## Report to the Future Melbourne Committee

### Planning Permit Application: TP-2021-28 57-59 Wakefield Road, Kensington

## DELEGATE REPORT

<b>Application number:</b>	TP-2021-28
<b>Applicant / Owner / Architect:</b>	Plan Urban / Odette Kasab / SDS Developments Pty Ltd
<b>Address:</b>	57-59 Wakefield Street, KENSINGTON VIC 3031
<b>Proposal:</b>	Development of two dwellings on the site and a car parking reduction pursuant to Clause 52.06
<b>Cost of works:</b>	\$870,000
<b>Date of application:</b>	22 January 2021
<b>Responsible officer:</b>	Michelle Fernando, Senior Urban Planner

DRAWING TITLE	SHADOW ANALYSIS 9am to 3pm
---------------	----------------------------

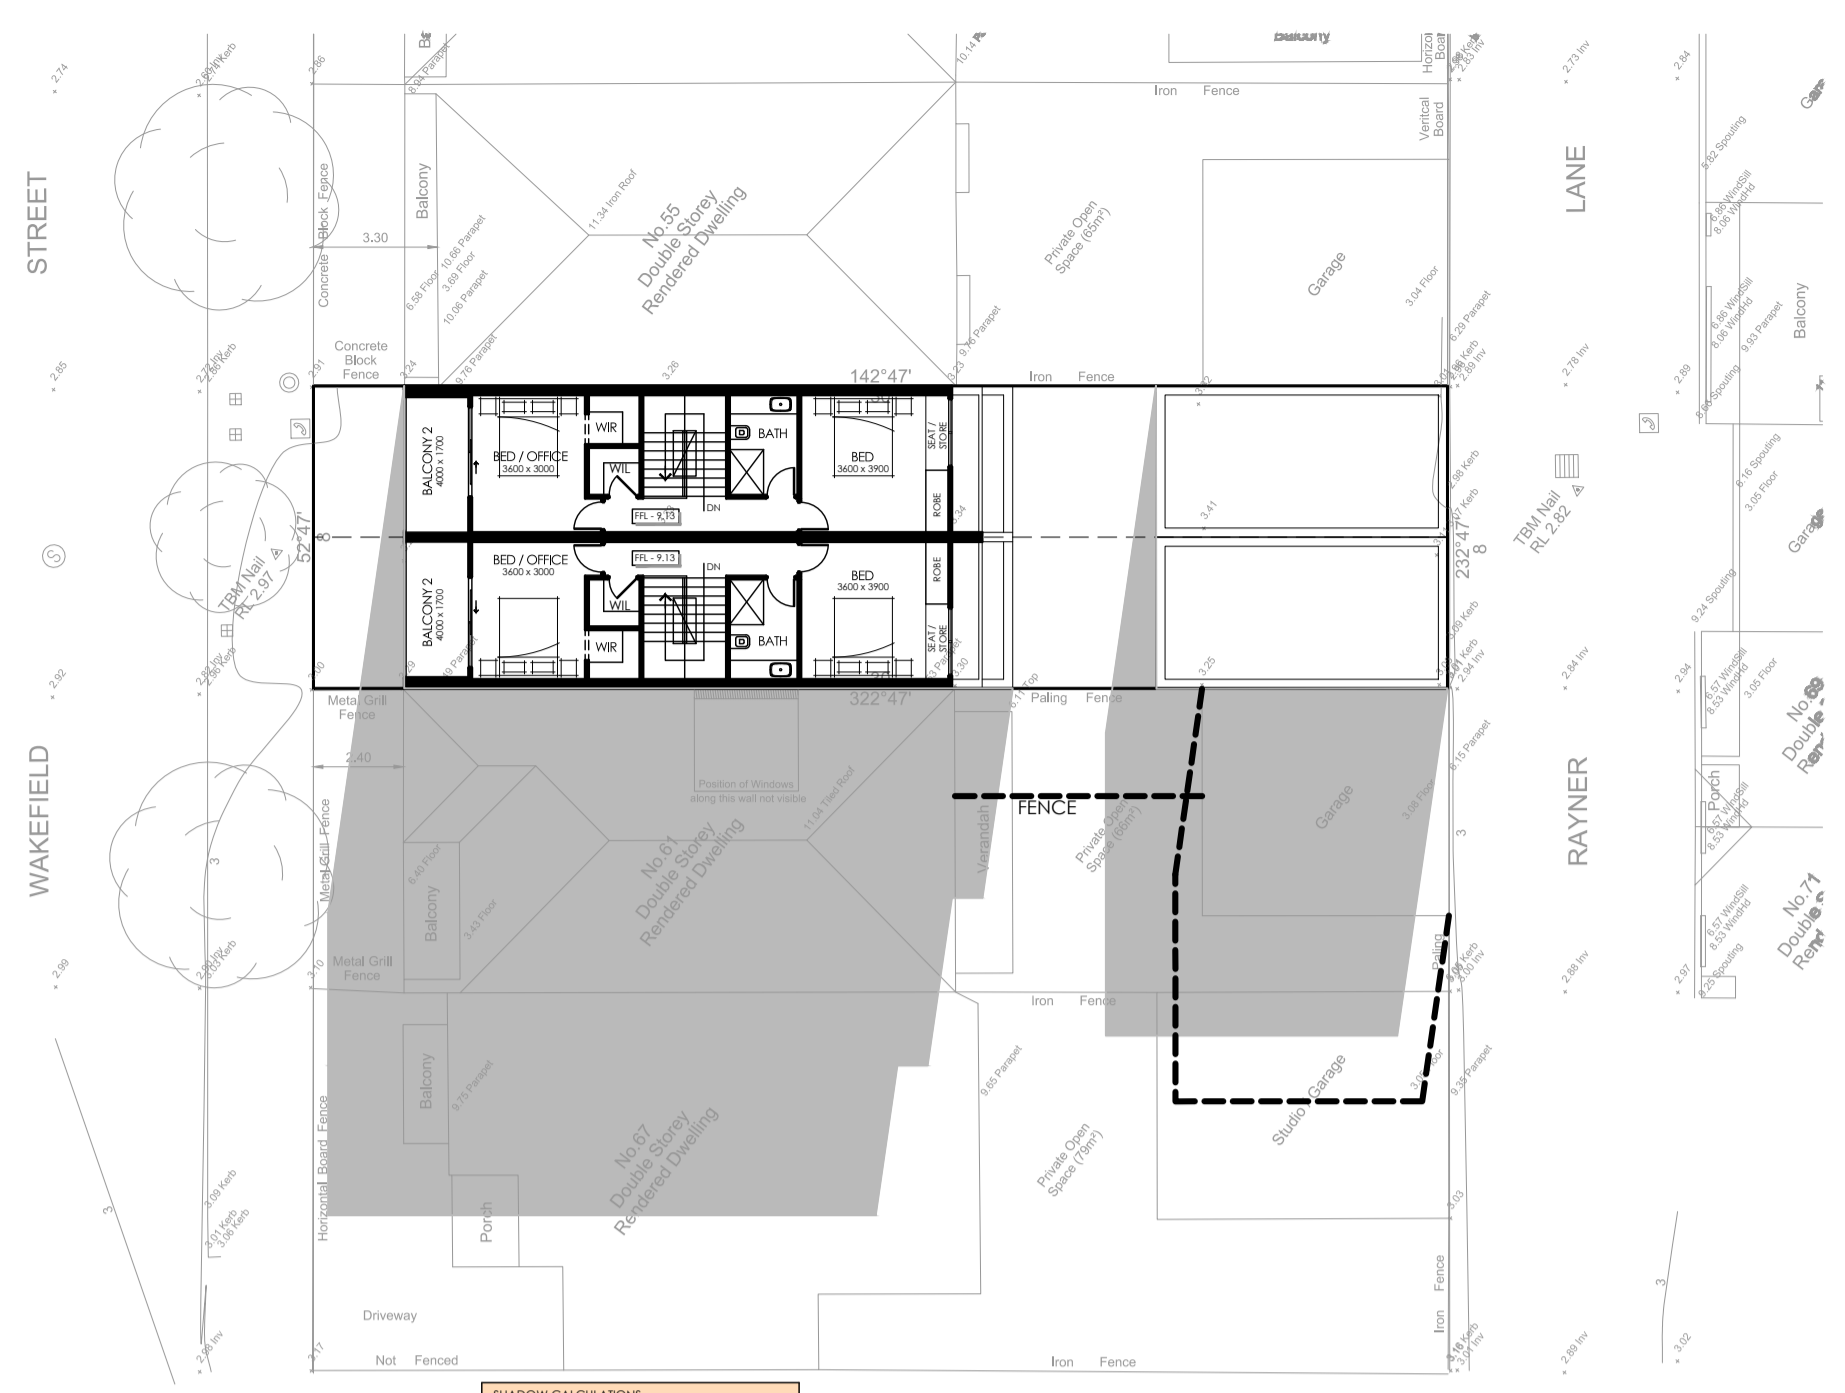
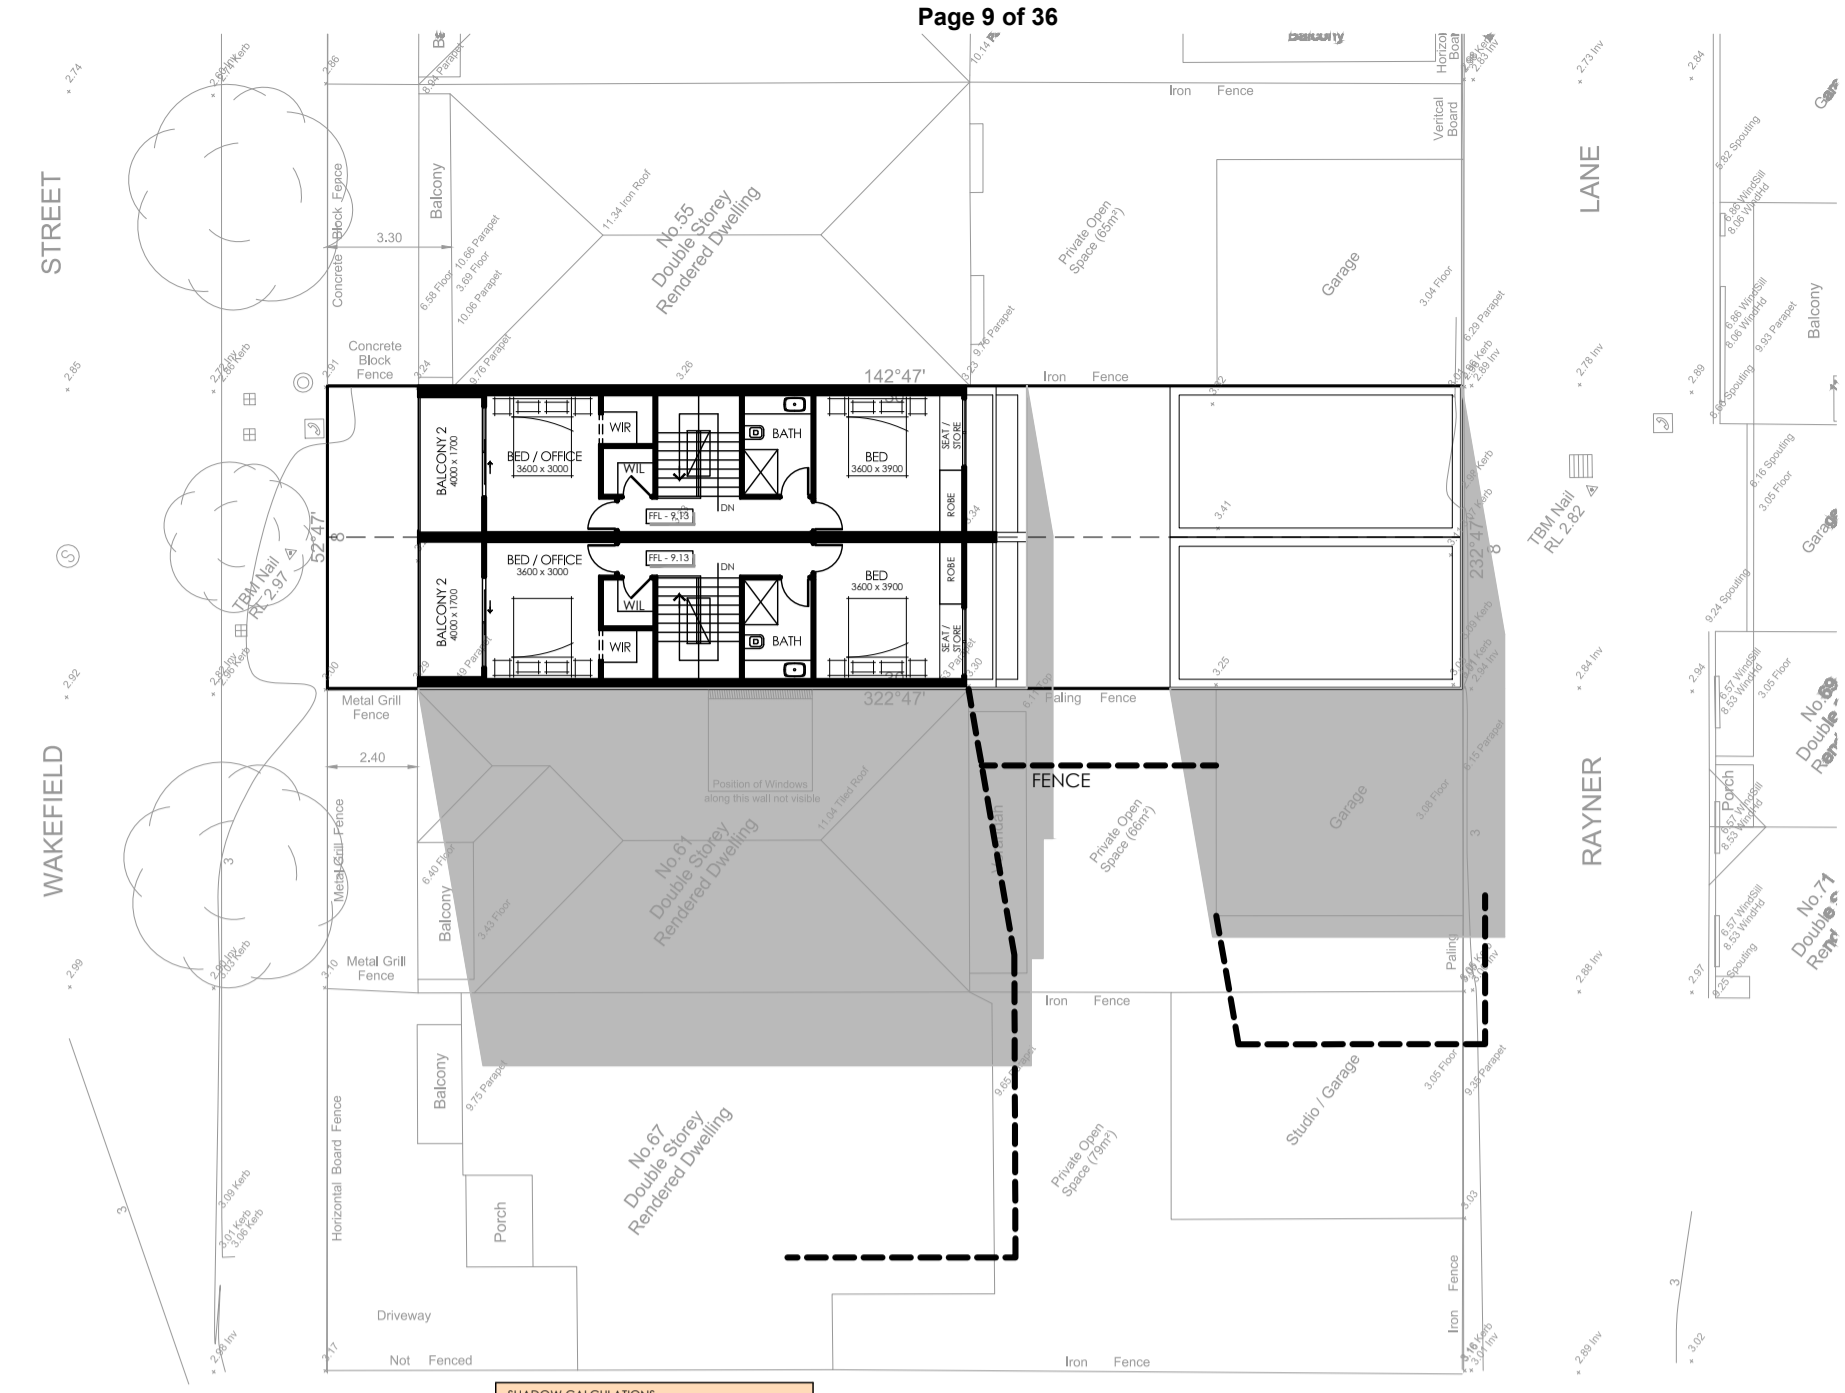
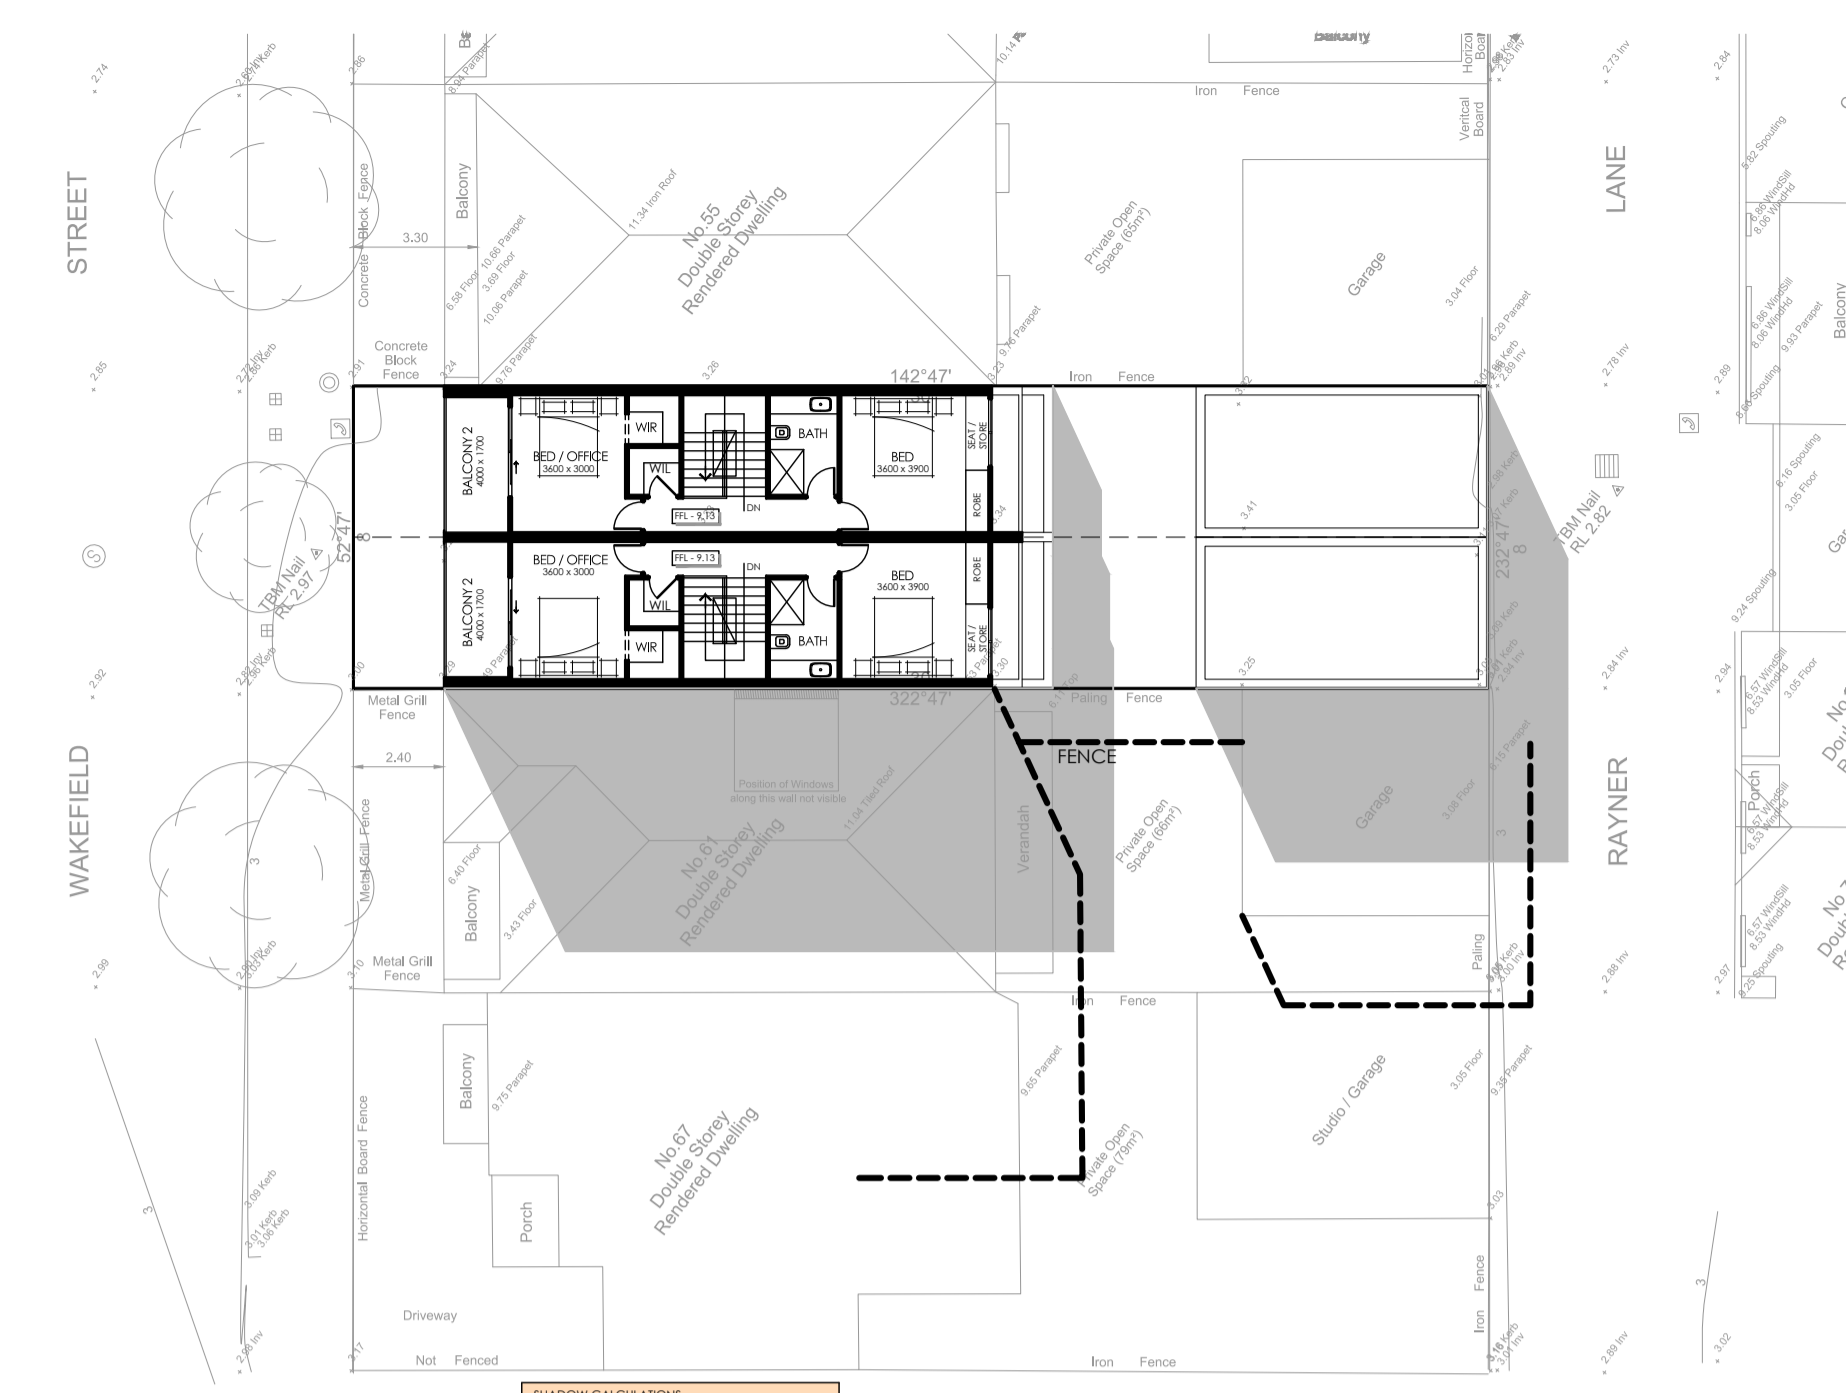
61 Wakefield Street						
	Minimum unshadowed POS required (m <sup>2</sup> )	Existing unshadowed POS (m <sup>2</sup> )	Complies?	Proposed change in shadow (m <sup>2</sup> )	Proposed sunlight (m <sup>2</sup> )	Complies?

<b>9:00 AM</b>	39	30	N	12.27	17.73	N
<b>10:00 AM</b>	39	33.75	N	9.21	24.54	N
<b>11:00 AM</b>	39	30.7	N	8.02	22.68	N
<b>12:00 PM</b>	39	21.77	N	8	13.77	N
<b>1:00 PM</b>	39	13.68	N	5.05	8.63	N
<b>2:00 PM</b>	39	3.94	N	0	3.94	N/A – No change
<b>3:00 PM</b>	39	2.96	N	0	2.96

<b>55 Wakefield Street</b>						
	Minimum unshadowed POS required (sqm)	Existing unshadowed POS (sqm)	Complies?	Proposed change in shadow (sqm)	Proposed sunlight (sqm)	Complies?
<b>9:00 AM</b>	39	31.46	N	0	31.46	N/A – No change
<b>10:00 AM</b>	39	33.98	N	0	33.98	
<b>11:00 AM</b>	39	33.94	N	0	33.94	
<b>12:00 PM</b>	39	21.28	N	0	21.28	
<b>1:00 PM</b>	39	12.59	N	0	12.59	
<b>2:00 PM</b>	39	0.53	N	0.53	0	N
<b>3:00 PM</b>	39	2.96	N	2.96	0	N

Minor errors in the plans have been noted and the applicant has provided revised shadow diagrams that correct the veranda of 61 Wakefield Street to an open pergola and height of parapet wall.
